Local Planning Panel

Address: 16-22 Cooper Street, Surry Hills

Application: D/2025/1198

Construction of an eight storey mixed-use development:

built form context

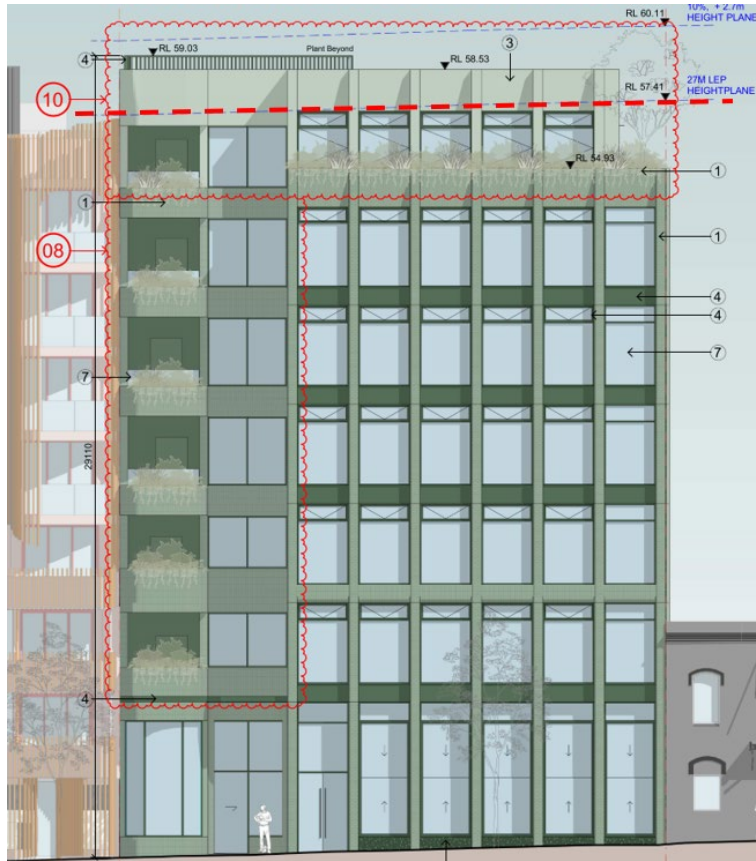
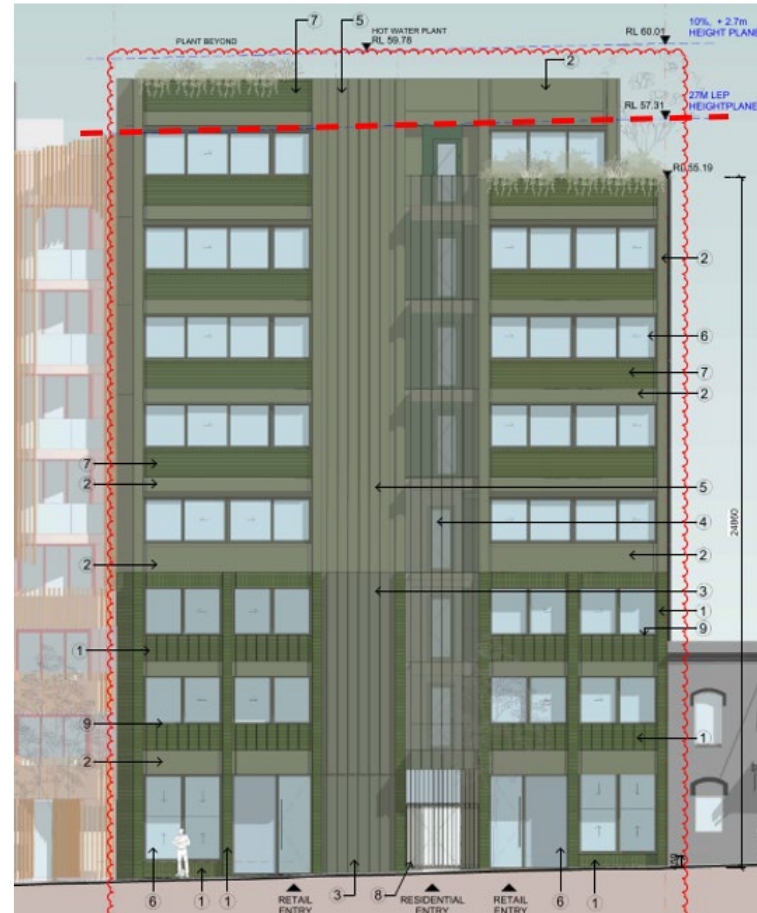
- non-compliance with 27m height control
- proposal is 29.7m
- complies with 8 storey DCP height control
- height is contextually appropriate
- height is generally consistent with the previously approved building envelope - D/2023/904 (29.67m)
- no unreasonable overshadowing or overlooking to neighbours
- CI 4.6 variation request is supported

Street frontage height

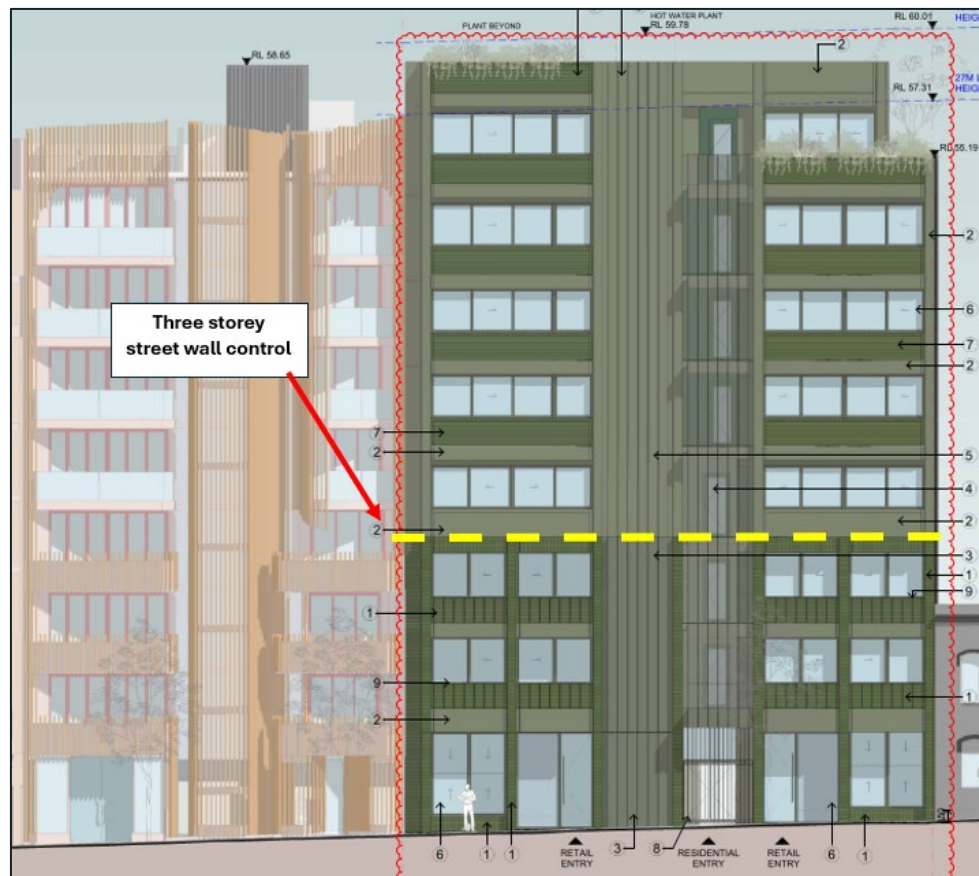
- three storey street wall height to Cooper St
- proposal incorporates a partial setback to upper levels
- splayed interface with neighbouring building at 10-14 Cooper St
- utilises materiality and architectural expression to acknowledge three storey street wall control

Communal open space

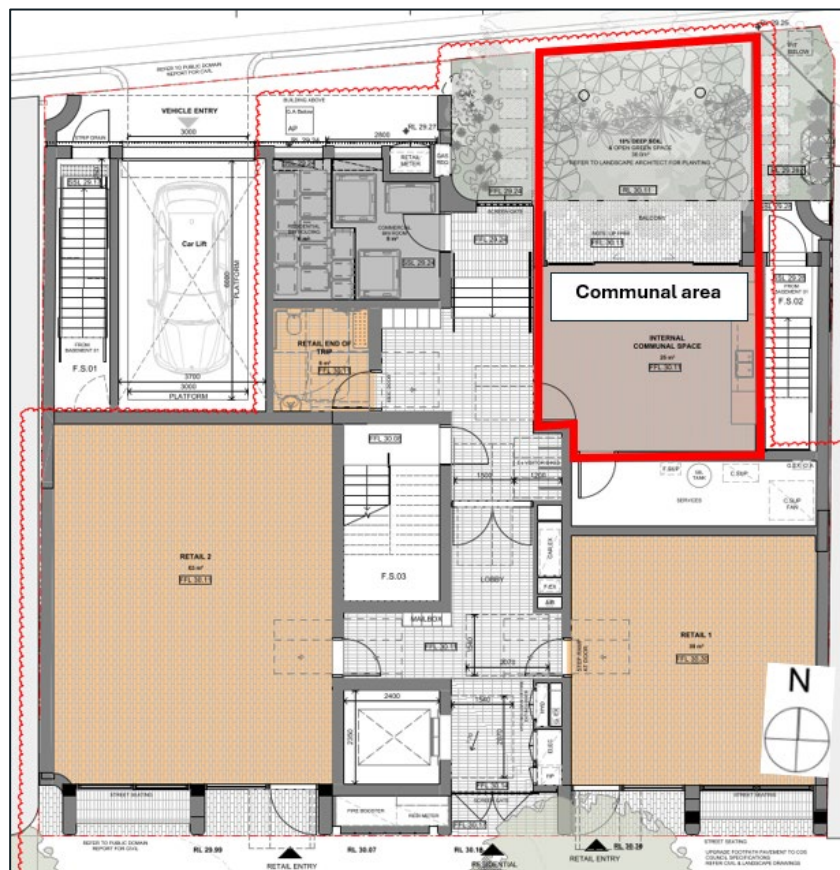
- non-compliance with 25% communal open space requirement of ADG
- proposal provides 14% (53 sqm) communal area at ground floor
- proposal meets ADG objectives and design criteria in that:
 - communal open space is co-located with deep soil area
 - provides kitchen facilities and enhances amenity
 - all apartments feature balconies which exceed ADG size requirements
- complies with DCP controls - incorporates soft landscaping, located with north aspect, passive surveillance to street, and provides for needs of residents

communal open space

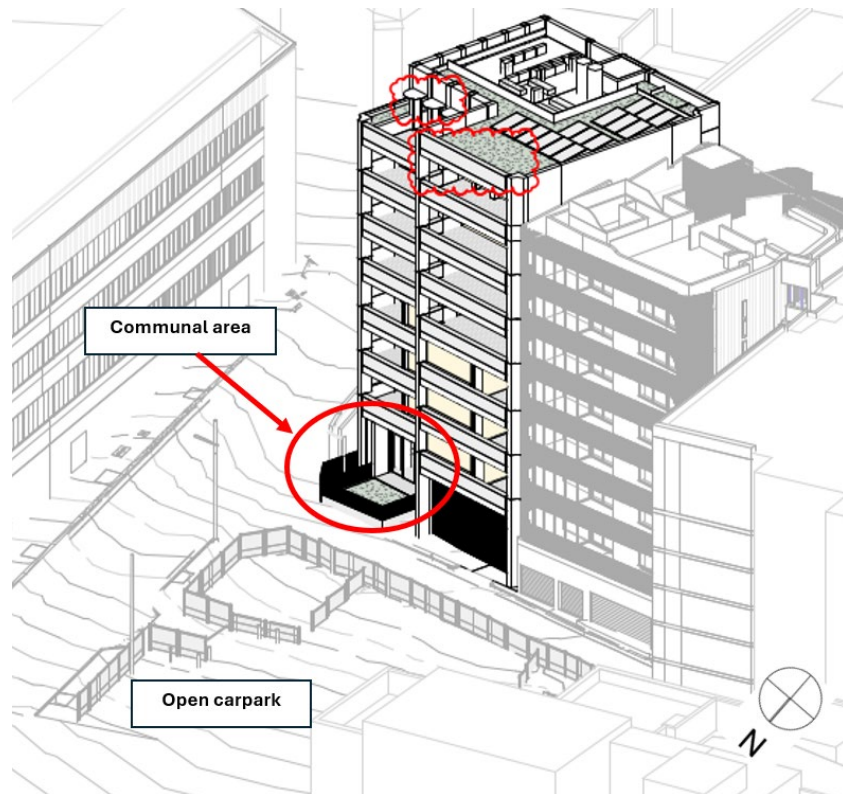
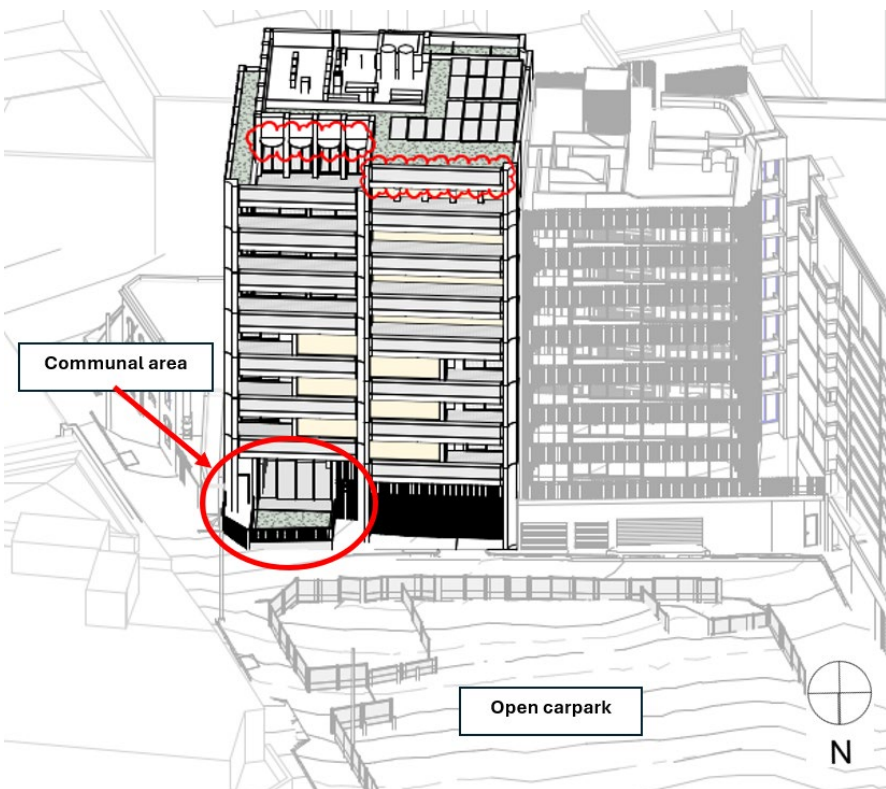
- ADG requires “direct sunlight to 50% the principal usable part of the communal open space for a minimum of 2 hours between 9am and 3pm mid-winter”
- communal open space receives direct sunlight to at least 50% of both the indoor and outdoor space from 11am to 2pm mid-winter
- any future development of the open car park will reduce direct sunlight

Waste holding area

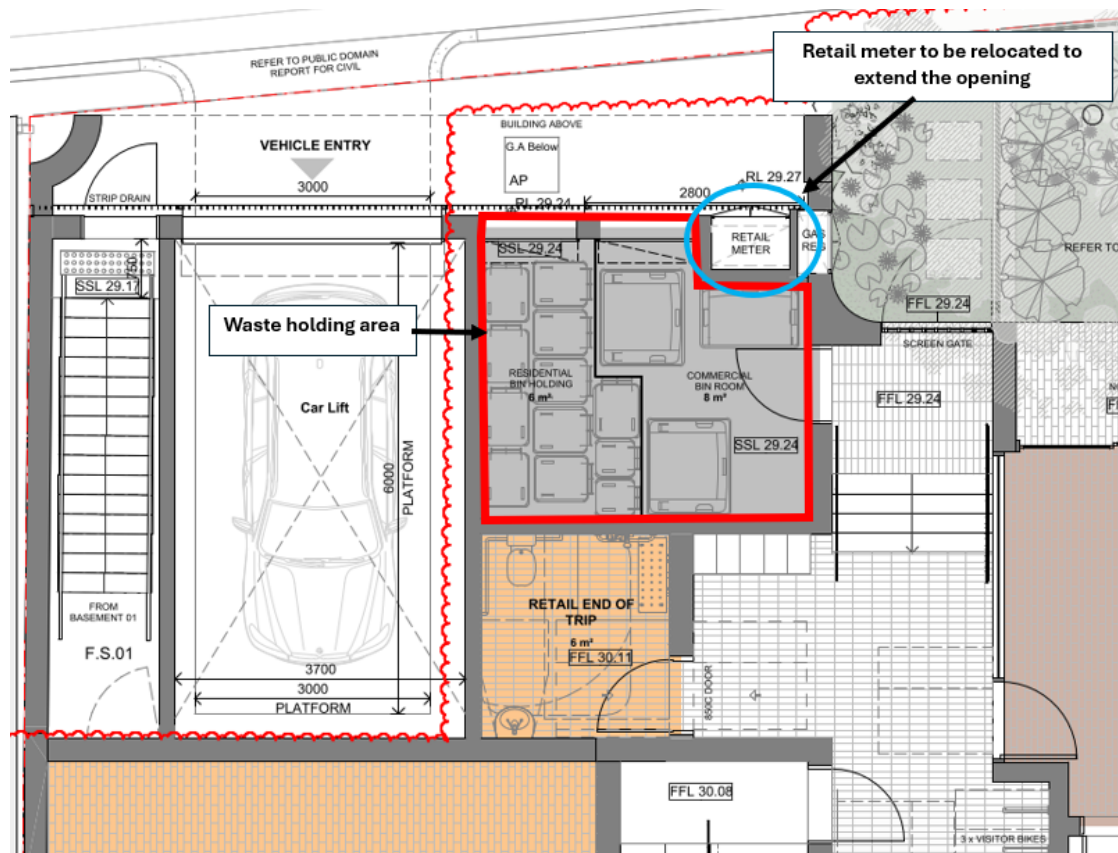
- waste holding area proposed at ground floor at rear of building
- space provided is insufficient to allow each waste stream to be wheeled out independently
- proposal meets ADG objectives and design criteria in that:
- condition recommended requiring waste holding area to be reconfigured to allow for improved access and sufficient circulation space

- reconfigure the ground floor waste area/bin room to improve access to bins and manoeuvrability
- provide physical materials and samples board
